ERRATA SHEET

Date:2008 Mar 10Document Release:Version 1.2Device Affected:P89LPC906

LPC906 Erratasheet

Figure 1: Flowchart ICP Global Erase

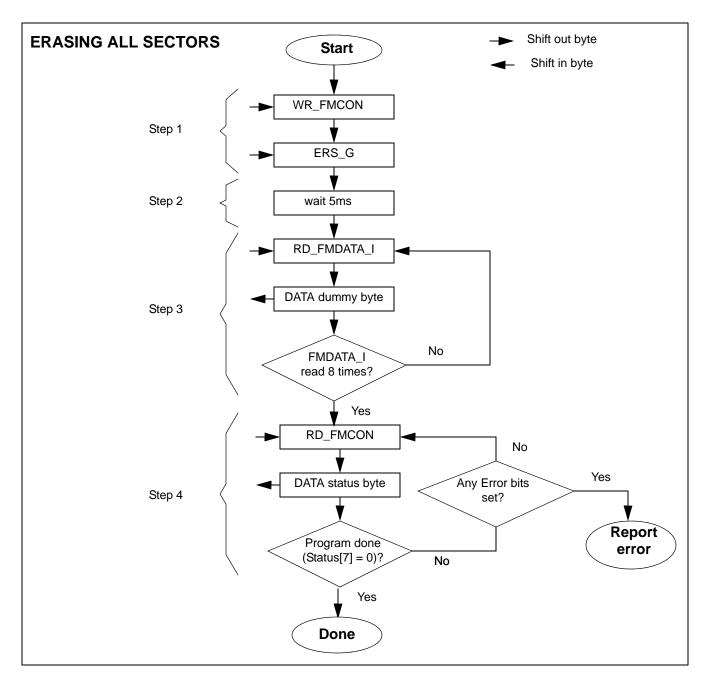
- Introduction: The LPC906 can be programmed using ICP (In Circuit Programming). One of the ICP functions is the Erase Global command, which will erase the entire chip including the security bytes and configuration information.
- Problem: When giving the Erase Global command through the ICP interface the LPC906 will not clear the busy flag and stay busy forever.
- Workaround: The workaround can be done in 4 steps:
 - Step 1: Shift out the WR_FMCON command followed by the Erase Global opcode.

Step 2: Wait 5ms.

Step 3: Do 8 dummy reads with the RD_FMDATA_I command.

Step 4: Read FMCON until the busy flag gets cleared.

Please also see figure 1 on the following page.
